工程指示 / 要求簡箋(E.I.)

工程指示編號：EI / 5527 / 22 (原 EI 5272) 修改版次：C
 工程編號：J - 858 工程名稱：將軍澳日出康城 LP 11
 工程項目：幕牆 大貨單元件加工圖
 收件人：生統 發件人：Ant Yeung 日期：27/01/2023

"ginnychau@rlp.asia"
<ginnychau@rlp.asia>,
"wallaceng@rlp.asia" <wallaceng@rlp.asia>,
"rss19084mw@rlphk.com" <rss19084mw@rlphk.com>,
"andywchan@sino.com"
<andywchan@sino.com>,
"terrywan@sino.com" <terrywan@sino.com>,
"simonspleung@sino.com" <simonspleung@sino.com>,
"kennethleung@sino.com"
<kennethleung@sino.com>,
"stephenchow@sino.com" <stephenchow@sino.com>,
"Ko, Ryan" <Ryan.Ko@aecom.com>, "Lau, Daisy" <Daisy.Lau@aecom.com>,
"Wong,
Crystal" <crystal.wong@aecom.com>,
"Tso, Simon" <Simon.Tso@aecom.com>
Subject: LP11 - CW - onsite inspection issue
Date sent: Thu, 26 Jan 2023 05:28:37 +0000

J858单元幕墙胶条位置图

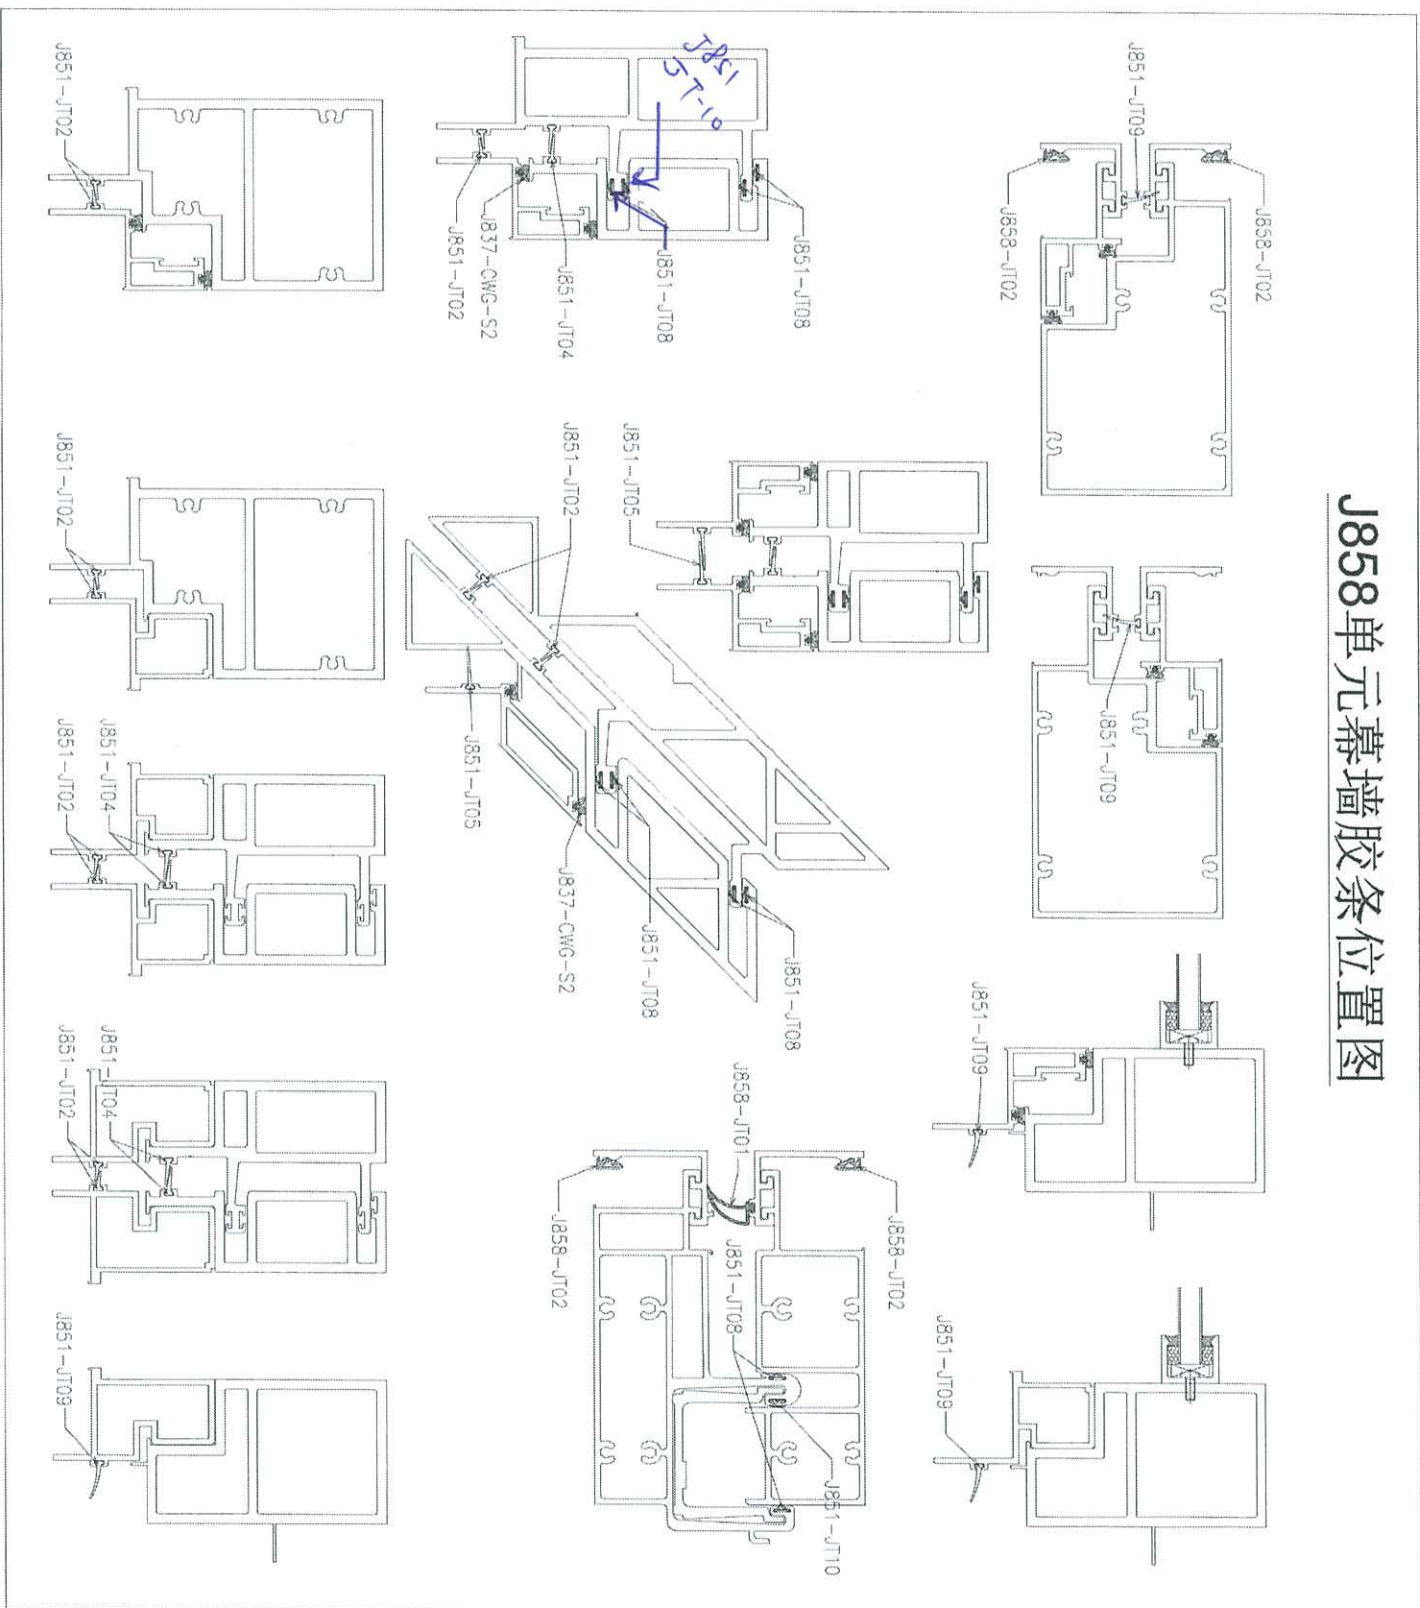
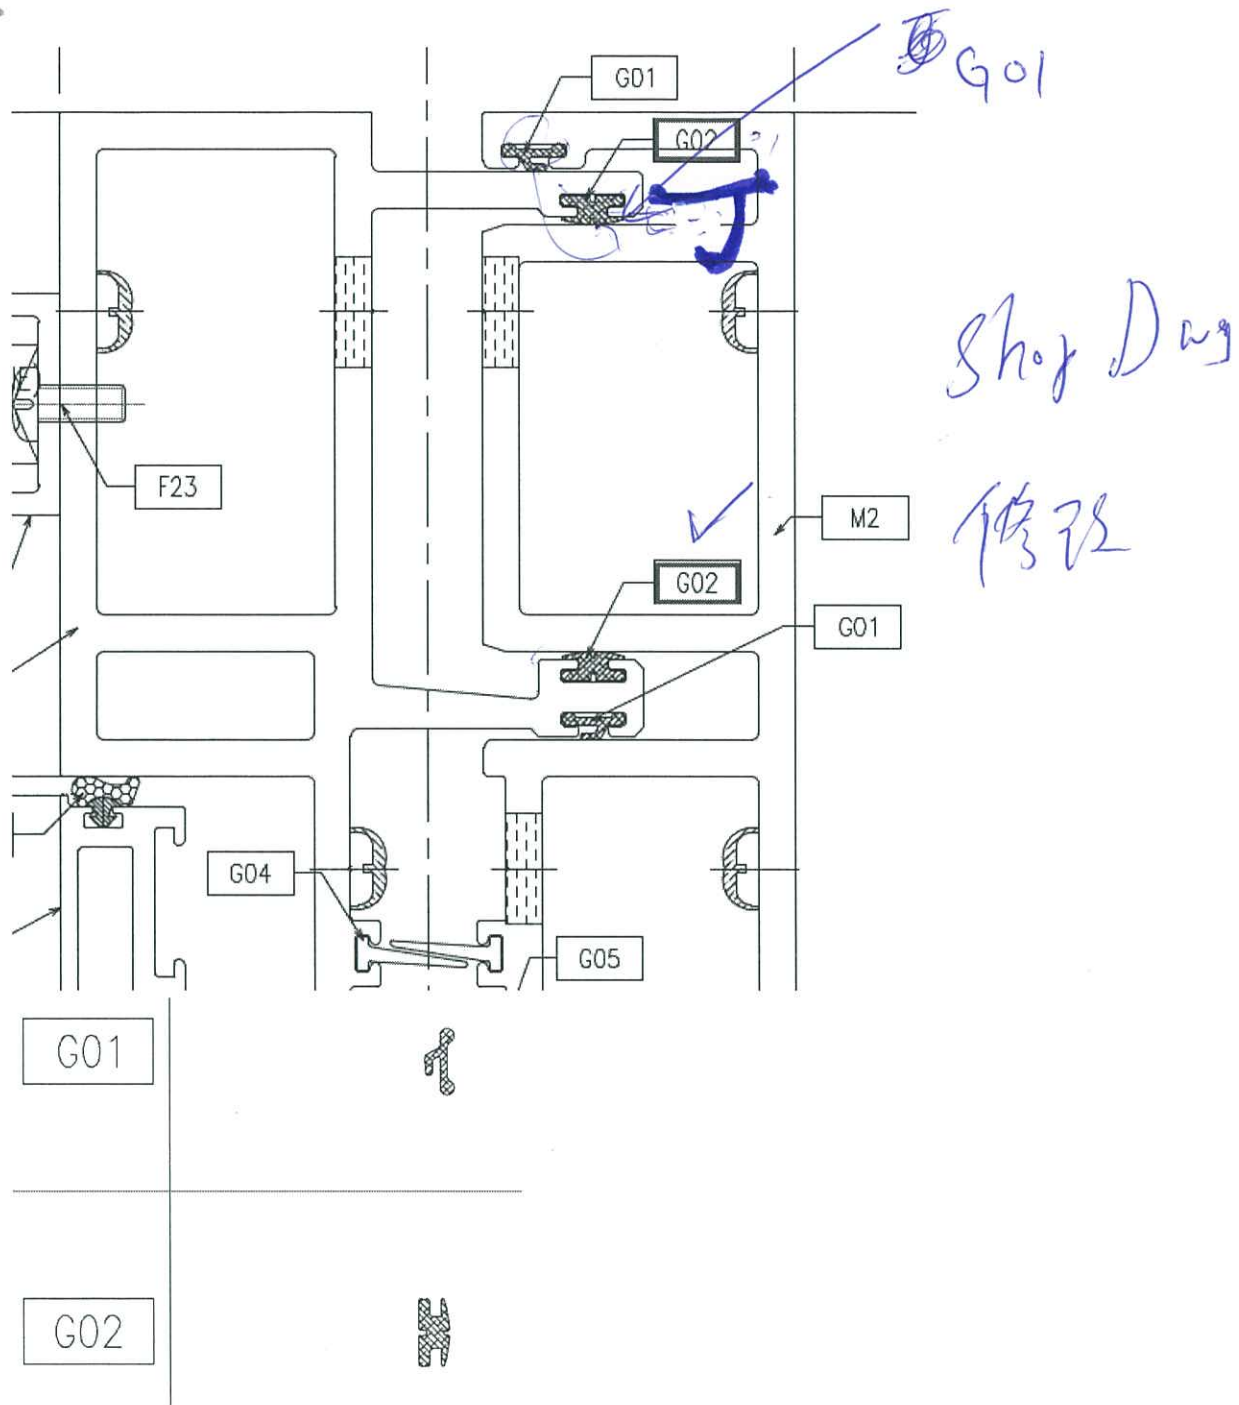
依拆图全用08, 太松

如图示配套, 略紧, 但可以装。

C 版: 顧問質疑公母企防水性能。圖紙, 廠成品, 地盆, -> 需要跟回試水場 (3 條 JT08, 1 條 JT10)。
 廠成品-> 需要更換跟回試水場 (3 條 JT08, 1 條 JT10)。
 地盆, -> 需要更換跟回試水場 (3 條 JT08, 1 條 JT10)。

1. Mullion gasket type revise

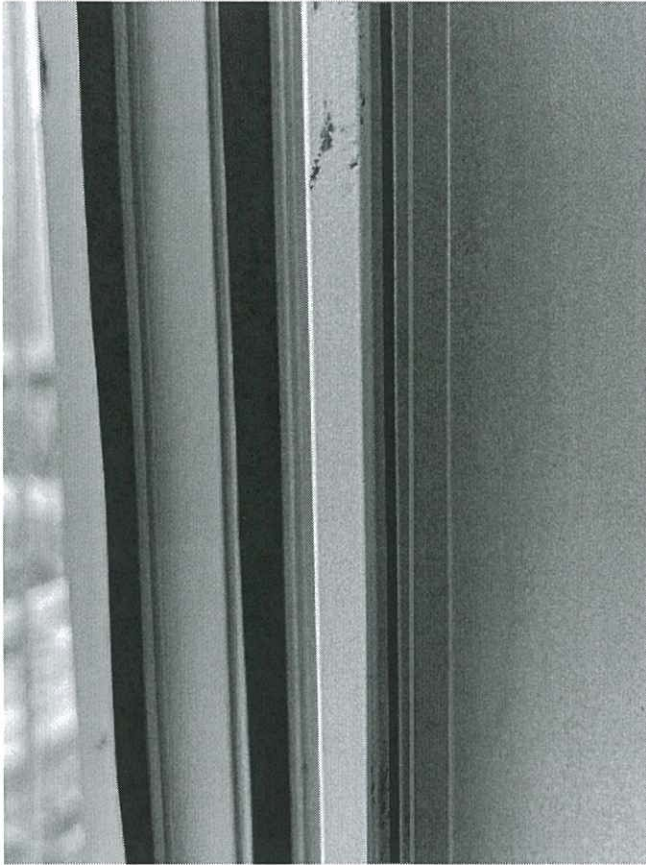
The onsite pre- assembled gasket surface is observed to below the extrusion surface which cannot performance as a reliable water barrier.

The pre-assembled gaskets on male mullion is observed to be not in line with shop drawing design, which may have influence on the whole system water tightness performance.

Please provide clarification and:

- a. Replace the gasket on installed panels.
- b. Double check for other onsite stored units and revise is necessary.
- c. Carry out the QA/QC method at factory panel accurate fabrication work to guarantee all works are in line with approved shop drawings.

2. Cut off the excessive gasket

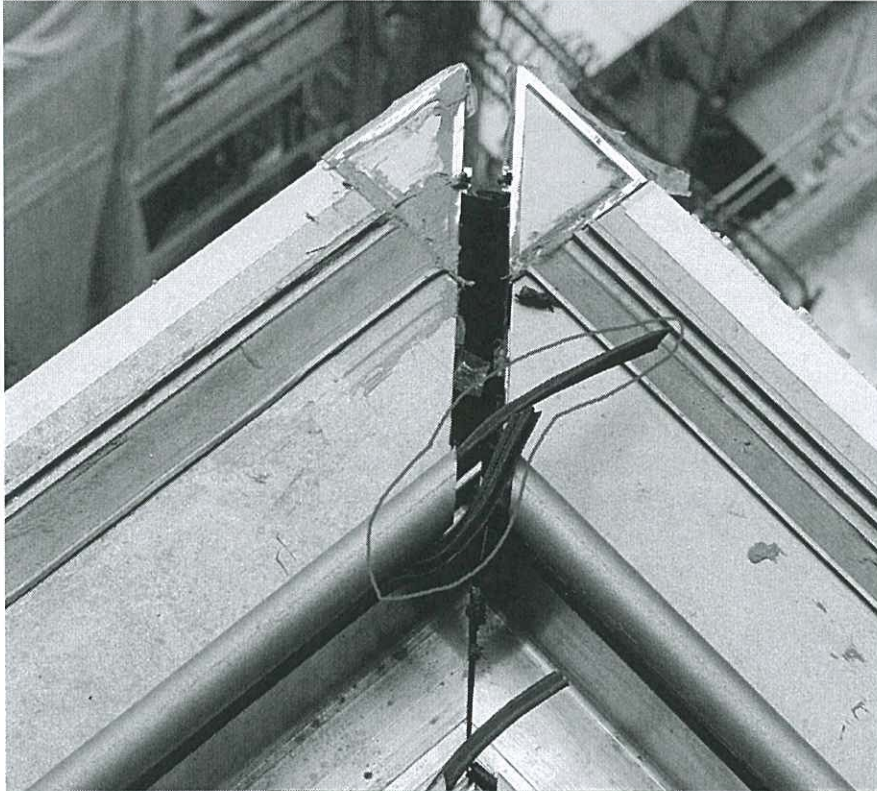
The pre-assembled gaskets on installed units is observed to be with excessive part.

Please cut off the excessive part without causing any defect on its performance before next unit constructions work processes.
